PROJECT NO. AH20300003
EDISON IMPACT HUB ABATEMENT AND DEMOLITION
DESIGN-BID-BUILD

ADDENDUM NO. 2

ISSUE DATE: July 26, 2023

S0.2

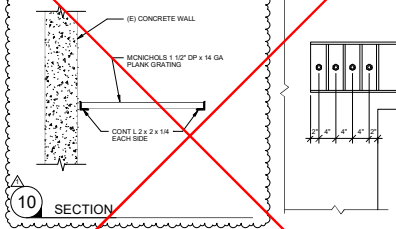
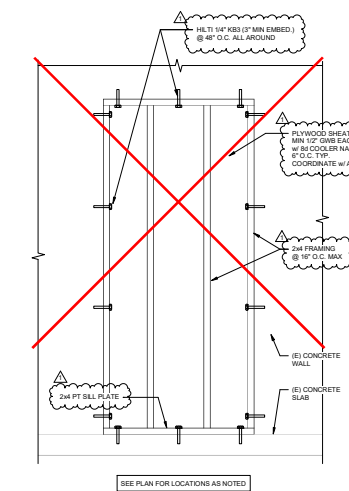
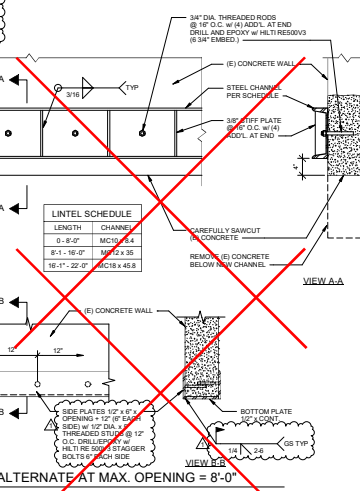
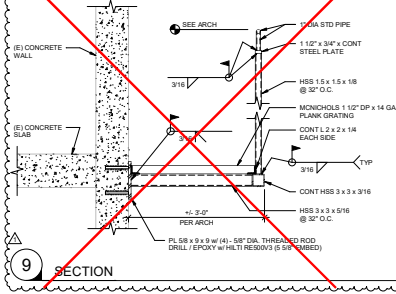
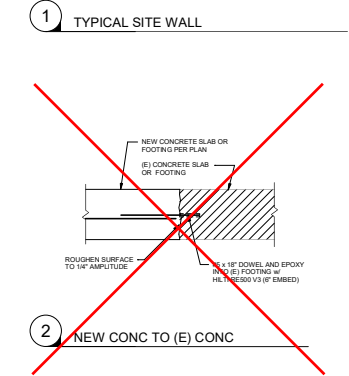
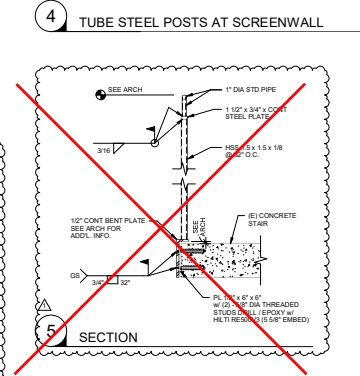
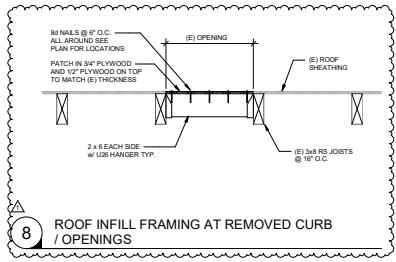
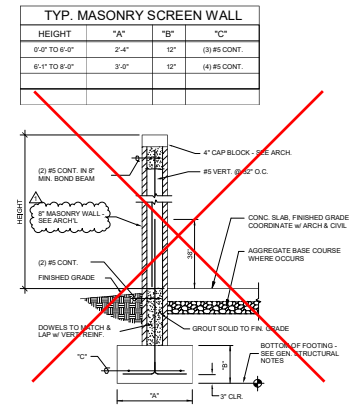
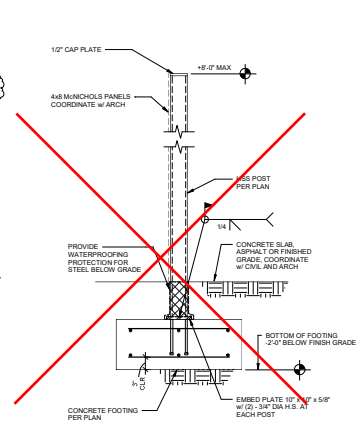
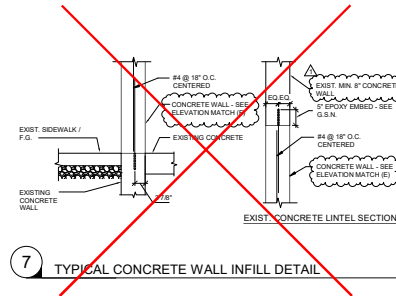
1. Add Plan Sheet S0.2, Detail 8.

A9.	All flooring must be removed.
Q10.	Is removal and disposal of universal waste included in this contract?
A10.	See "Additional Specifications Regarding Hazardous Waste Disposal", attached to this Addendum.
Q11.	Clarify the detail at the building separation locations. Upon demolition, can the new perimeter doors just be closed and locked?
A11.	There are two pair of existing door openings on the west façade of the historic building. 1) At North doors, close and lock existing doors. 2) At south door opening, the existing doors have been removed. Contractor shall provide temporary infill at existing 6'-4" W x 7'-0" H opening as follows: Frame opening with 2x4 wood stud infill, provide ¾" plywood sheathing on exterior of stud framing. (response by Multistudio/Gould Evans).
